Public Meeting

Colchester/Riverside/Barrett/ Mill Intersection Study / 195311163

Date/Time: May 23, 2016 / 7:00 PM
Place: UVM Medical Center Conference Room
Next Meeting: October-September
Attendees: See Attachment 1

Roundabout

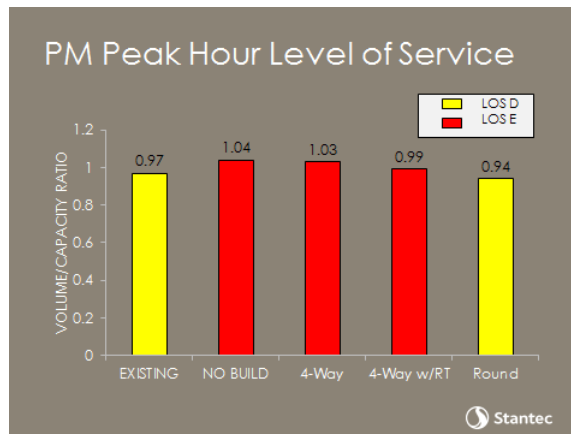
roundabout. He wonders if a single lane roundabout's efficiency would more closely match the efficiency of the other two long term alternative. Rick addresses Jason clarifying that the 2 lane roundabout analysis yielded a 1.18 V/c ratio while the 1 lane roundabout yielded a 1.58 V/C ratio. This analysis eliminated the possibility of a one lane roundabout.

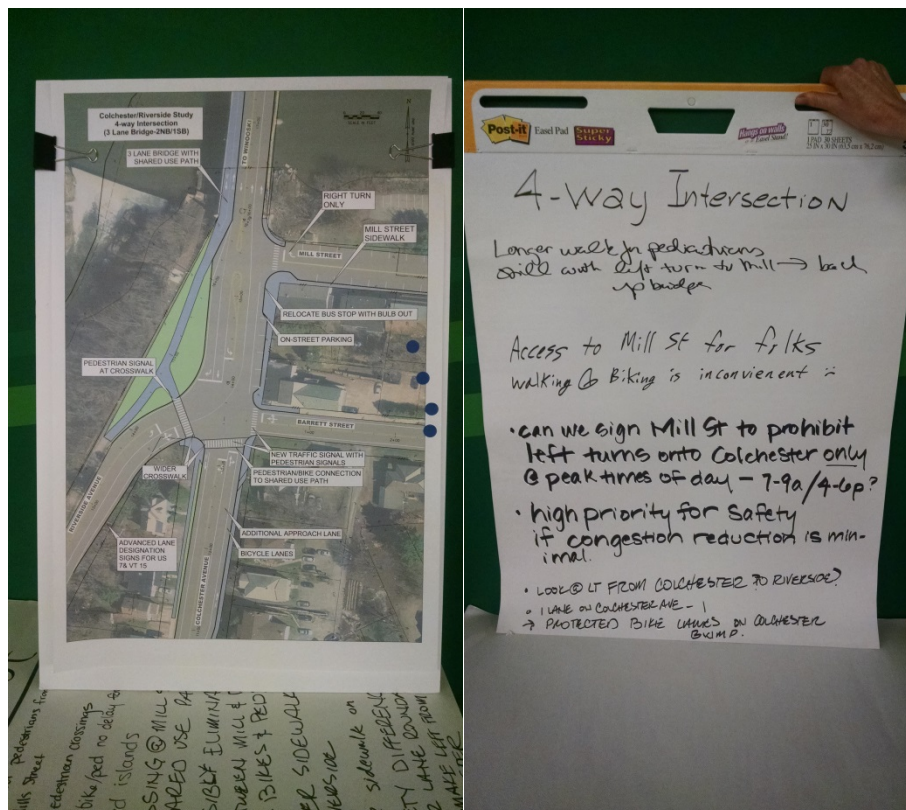
1. Provide Bicycle access to Mill Street - potentially adding a crossing with signals
2. Add an additional lane traveling northbound on Colchester Avenue.
3. Add features to divert traffic from Mill Street to exit out of Barrett Street.
4. Update existing signal timing as well as incorporating pedestrian signals
5. Delineate parking on Colchester Ave between Barrett and Mill St.
6. Prioritize which features are most important to incorporate into the intersection first.
7. Implement the short term improvements now
8. Work with Chase Mill to provide an exit using the rear private drive.
9. Work with CCTA to provide a northbound Riverside Avenue bus stop.
10. Delineate road lanes through the intersection.

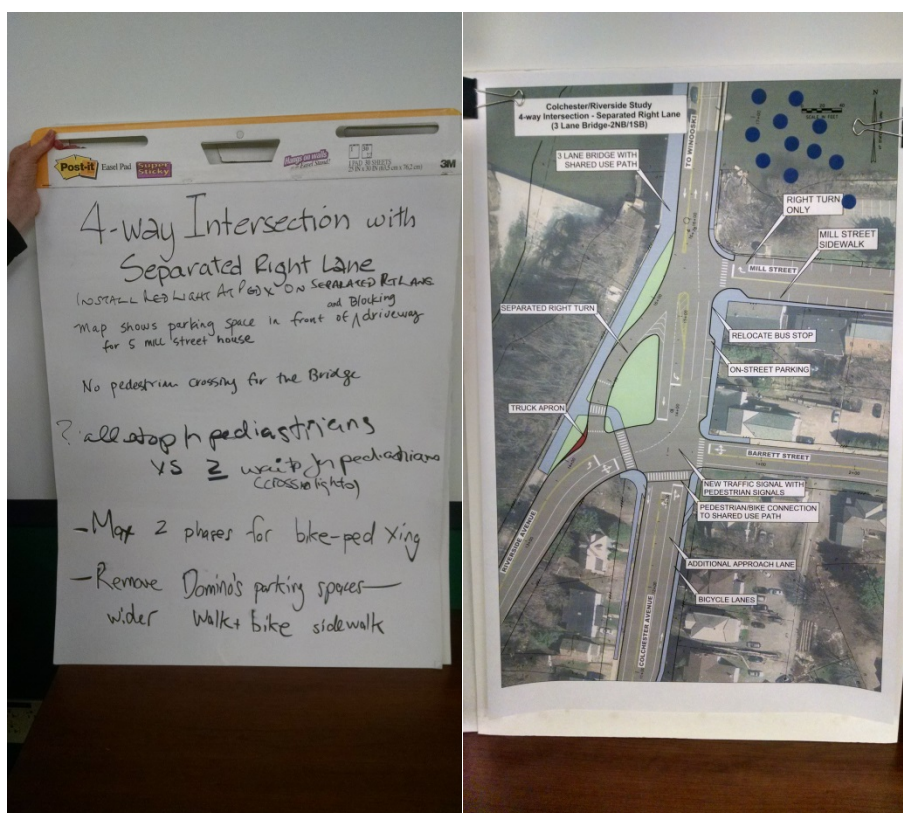
Jason summarizes the comments explaining that reviewers were concerned about the longer crossing over Colchester Avenue and the unprotected left turn for travelers onto Mill Street. The unprotected left turn would back up traffic and would yield an unsafe crossing for pedestrians. One comment proposed prohibiting left turns onto Mill Street during peak hours. Jason shares that that option will be further examined. Jason comments that the main priority of this alternative is safety improvements, not congestion management.

One resident asks about the potential of prohibiting left turns onto Riverside Avenue. He is curious if there would be any benefit from that and recommends further examination as a potential option.

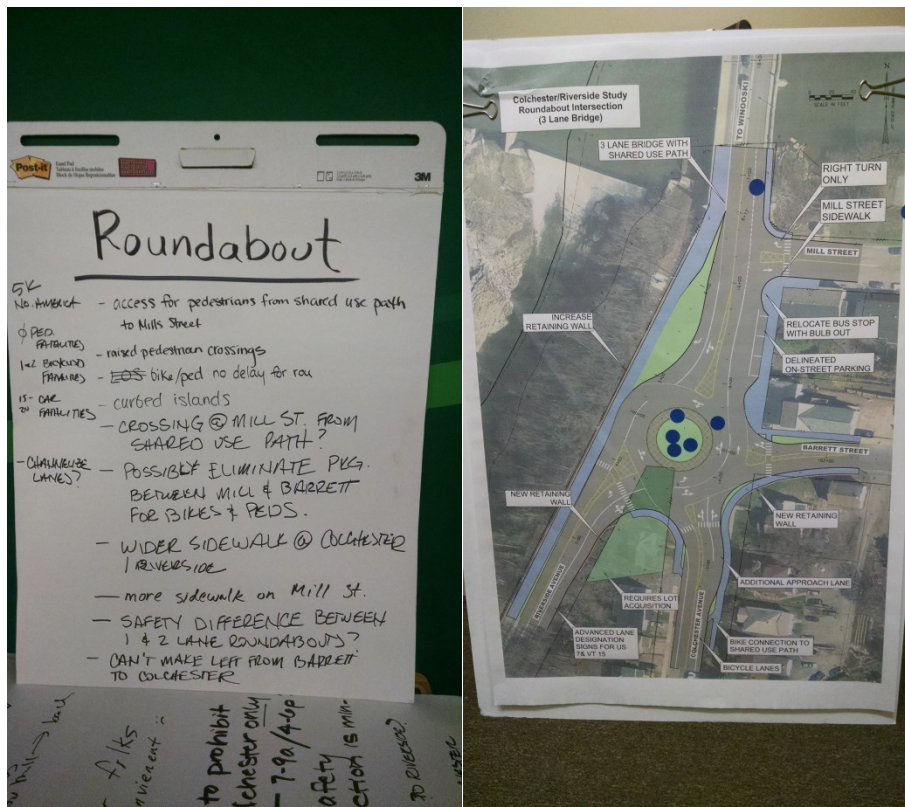
Carolyn summarizes the topics discussed at the roundabout station. This alternative received 7 votes. Many noted the lack of access for pedestrians that are trying to access Mill Street from the west side of the bridge. Incorporating this into the alternative was discussed. Ideas such as raised pedestrian crossings, curbed islands, providing a crossing at Mill Street to the shared use path, eliminating parking between Barrett and Mill street to provide a wider side walk or shared use path, and further channelizing the lanes with some form of curb were brought up to be considered into the design.

The overall safety and benefits of a roundabout were discussed at the station. There are 5,000 roundabouts in North America that have resulted in 0 pedestrian fatalities, 1-2 bicycle fatalities and 15-20 car fatalities. Some inquired about the difference in safety between 1 and 2 lane roundabouts. Roundabouts are considered a safe and efficient intersection design but it remains to be determined if this design works for the limitations and needs of this intersection.
